Memo

To: Cranston Planning Commission  
 From: Gregory S Guertin, MA – Senior Planner  
 Date: November 15<sup>th</sup>, 2022  
 Re: **“Orchard Meadows”** – Master Plan - Major Subdivision

# SITE PLAN (screenshot)

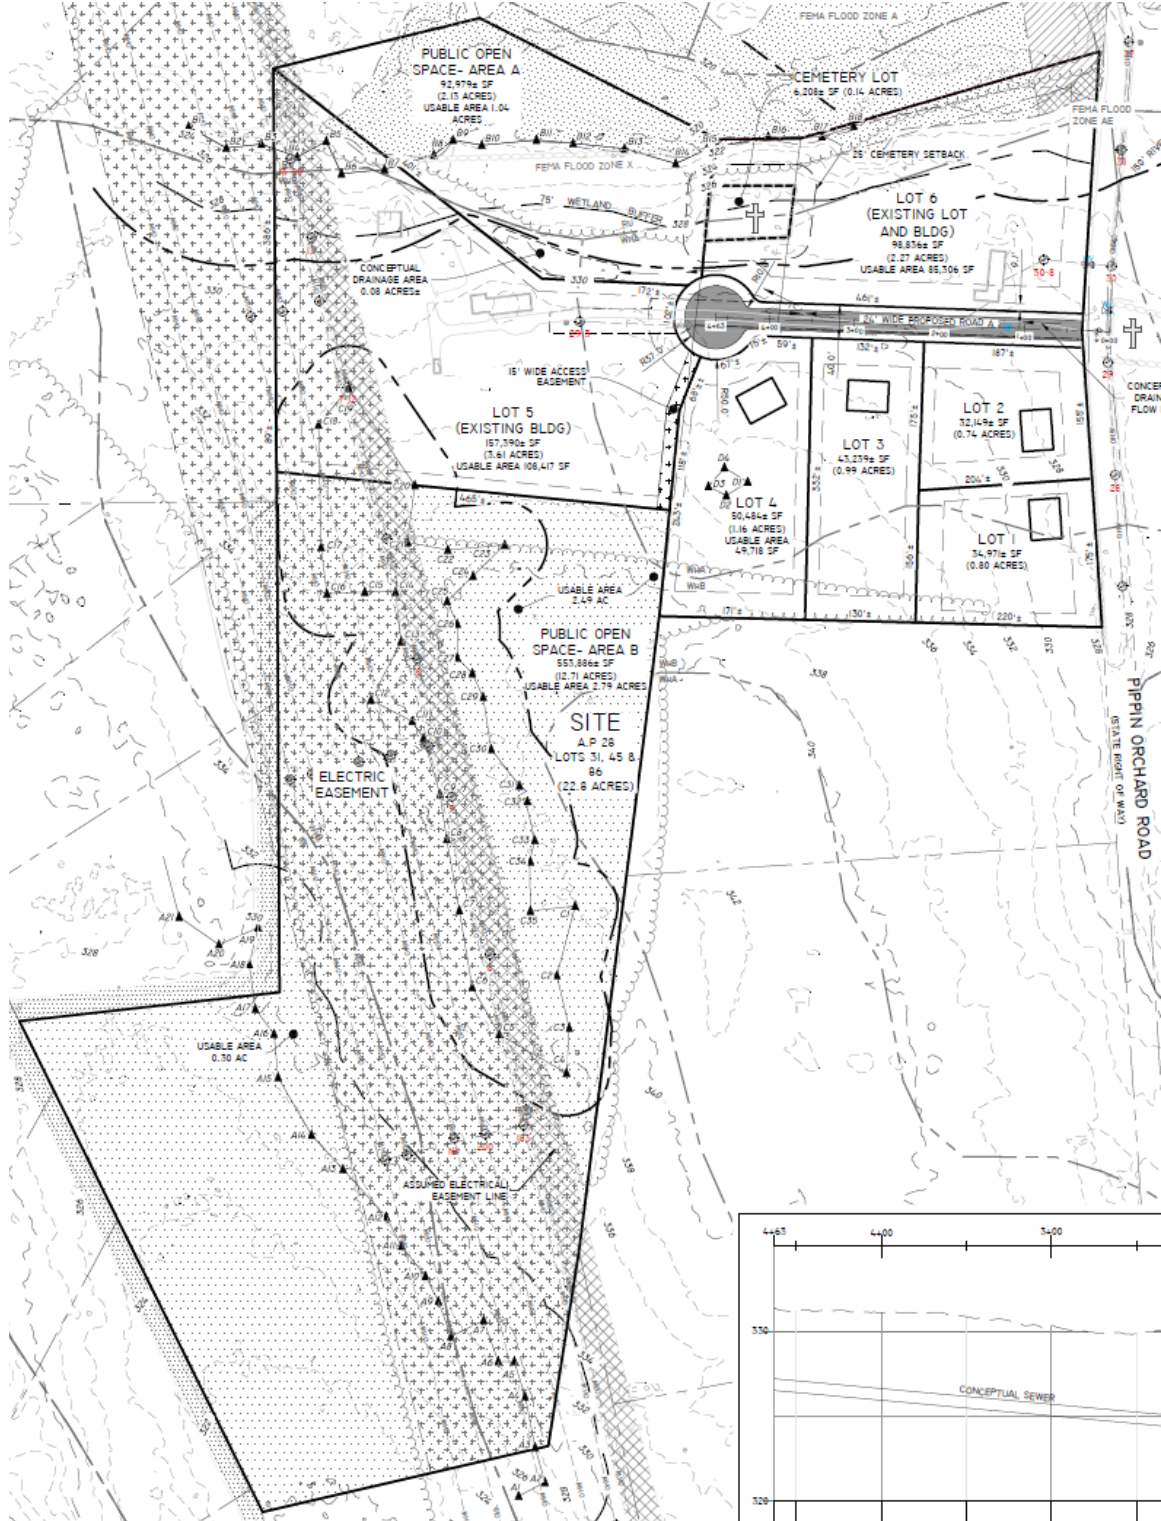
1. **The Providence Water Supply Board** – Has provided a letter regarding water availability.
2. **Veolia Water** – Has provided a letter regarding sewer availability.
3. **Public Works Department**
  - **Engineering Division** – Stated that they would not be in favor of providing a waiver for curbing requirements on the proposed public right of way. The applicant originally requested a waiver from the required curb requirement. The applicant has since retracted this request and excluded it from the Master plan proposal.
  - **Traffic Safety Division** – Reviewed the plan with planning staff and has no concerns at this time.
4. **Fire Department** – Reviewed the plan with staff and has no concerns at this time.
5. **Building and Zoning Department** – Reviewed the plan with staff and has no concerns at this time.

A Waiver from the sidewalk requirement has been requested. The applicant has proposed that no sidewalks need be constructed on this local road as it will only be used by residents of this subdivision. The applicant has cited RIDEM's general request to reduce impervious areas to the greatest extent possible and to request waivers when applicable.

A variance for the setback requirement has been requested. The existing residential home located on AP 28 Lot 10 will not meet the front yard setback and will be approximately 9' from the property line.

Staff have met with representatives from Fire, Public Works/Engineering, and Traffic. At that time, it was determined that the requested sidewalk requirement waiver and setback requirement variance would be appropriate for this scale of this development.

1. Prior to submittal of the Preliminary Plan application, the applicant shall obtain all necessary state permits and approvals for this proposed subdivision.
2. Proposed lot 6 shall obtain all necessary relief from the Zoning Board of Review **prior** to submitting the Preliminary Plan application.
